E C O L O G I C A L R E V I E W

Mississippi River Sediment Delivery System – Bayou Dupont
CWPPRA Priority Project List 12
State No. BA-39

November 7, 2007

David C. Lindquist
Restoration Technology Section
Coastal Restoration Division
Louisiana Department of Natural Resources

Figure 3. Estimated elevation change of the created marsh platforms over the 20-year project life (Thompson 2007).

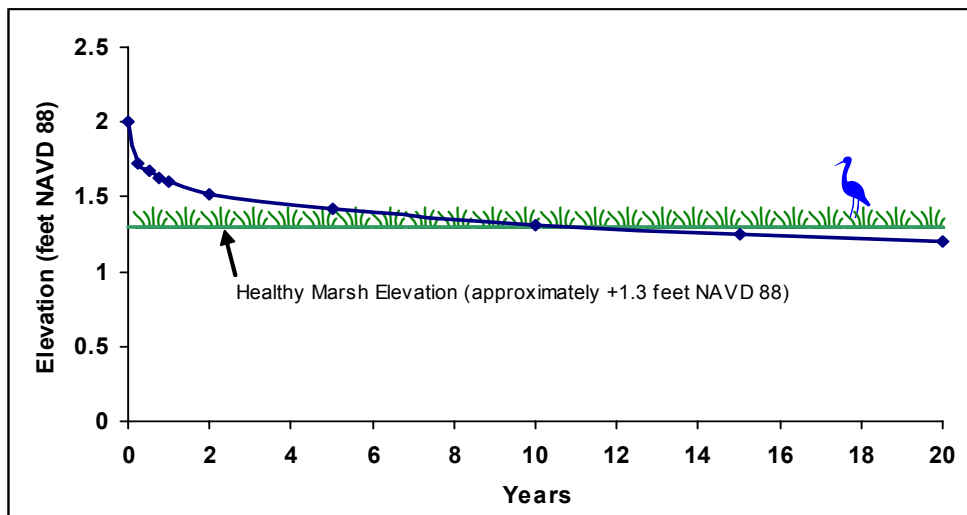
The average elevation of existing marsh in the project area is +0.88 feet NAVD 88 (T. Baker Smith and Son, Inc. 2005). However, this marsh consists of small patches of vegetation surrounded by open water and is not representative of healthy marsh. Consequently, project team members estimated healthy marsh elevation to be approximately +1.3 feet NAVD 88, based on best professional judgment and the local tidal datum. In addition, this elevation is nearly equivalent to that of the nearby Bayou Dupont - Dedicated Dredging (LA-01 b) created marsh (elevation: +1.34 feet NAVD 88), which appears to be very healthy (Thompson 2007). To determine the appropriate construction fill elevation, foundation settlement and self-weight consolidation tests were performed using soil samples collected from the marsh creation and borrow areas, respectively (Eustis Engineering Company, Inc. [EEC] 2006; Louis J. Capozzoli and Associates, Inc. [LJC] 2007). After evaluating a range of potential elevations, a fill elevation of +2.0 feet NAVD 88 was chosen because it would yield desirable marsh elevations for most of the project life. Filling to this elevation, most of the foundation settlement and self-weight consolidation would occur within two years after construction. The created marsh platforms would settle to +1.3 feet NAVD 88 at year 10, and to +1.2 feet NAVD 88 at the end of the 20-year project life (Figure 3).

Figure 4. Details of earthen containment dike and containment dike borrow area (Thompson 2007).

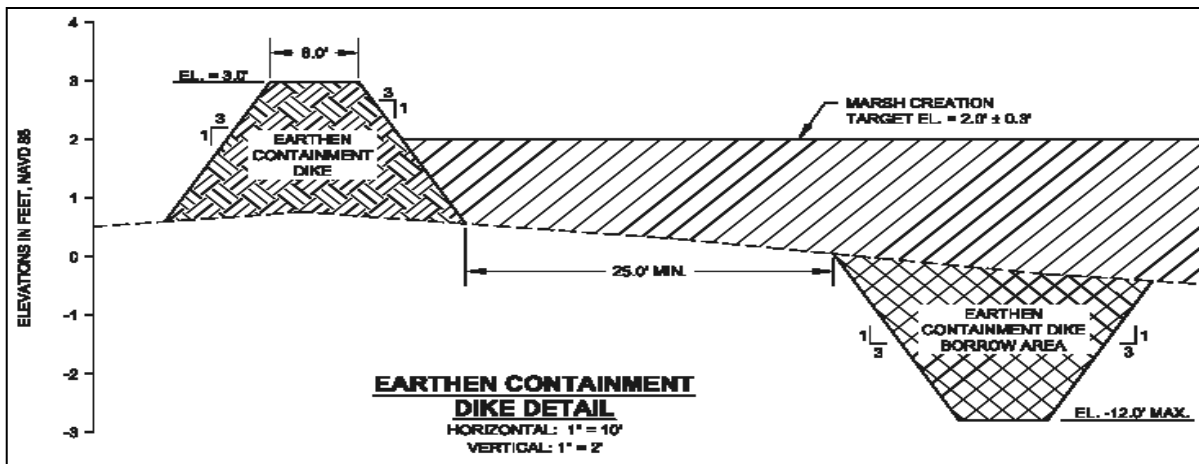
Eustis Engineering Company, Inc (2006) recommended that containment dikes be built with a crown elevation of +3.0 feet NAVD 88 (allowing one foot of freeboard above the marsh fill), a crown width of 6 feet, and side slopes of 1(V):3(H) producing a slope stability factor of 1.64 (Figure 4). The two marsh creation areas are mostly enclosed by pre-existing spoil banks and, therefore, a minimal amount of material will be needed to raise these banks to the recommended elevation. A complete containment dike, though, will be constructed on the southeastern boundary of Area 2. The dikes will be constructed using material mechanically-dredged from within the marsh creation areas.

Settlement of the containment dikes is estimated to be 1.0 to 1.25 feet over the project life (EEC 2006), which would result in the dikes being about 0.55 to 0.80 feet above the marsh platforms at year 20. Therefore, to achieve a consistent marsh platform elevation, the dikes constructed from existing spoil banks will be degraded to marsh elevation at the end of construction (Thompson 2007). The southeast dike of marsh creation Area 2, however, will likely remain in place to protect against erosion from wave action generated in the adjacent open water area (Whitney Thompson, LDNR, Personal Communication, October 10, 2007).

- If the degraded containment dikes remain above and impound the created marsh, then they should be mechanically-gapped to ensure tidal exchange.

Figure 5. Water level at the BA03C-61 gage for the years 2002 to 2006 (from LDNR data).

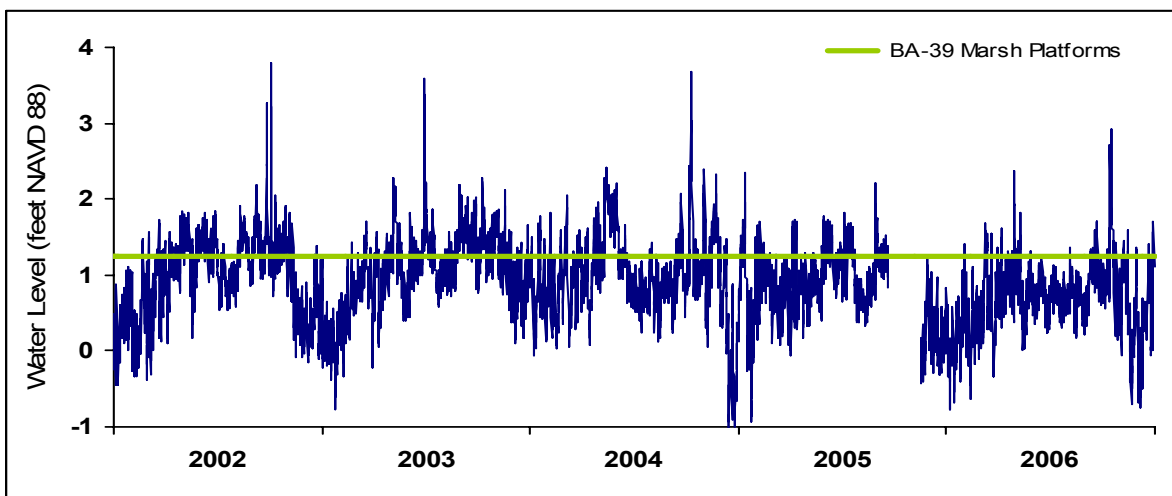
This review clearly shows that elevation is one of the most important factors dictating the success of marsh creation projects. The elevation of the marsh surface controls its frequency and duration of flooding, which in turn affects vegetation zonation and productivity. For the BA-39 project, the elevation of the marsh platforms would be around +1.2 to +1.3 feet NAVD 88 for much of the project life. At these elevations, the platforms would be inundated approximately 25% of the time, based on five years of water level data from the nearby BA03C-61 gage (29°37'23.30"N, 90°01'53.18"W) (Figure 5). Although this level of inundation is lower than optimal for many species of emergent vegetation, it would be suitable for the locally-dominant *Spartina patens*, which is less tolerant of flooding and more productive in irregularly-inundated habitats (Burdick and Mendelsohn 1987, Broome et al. 1995).
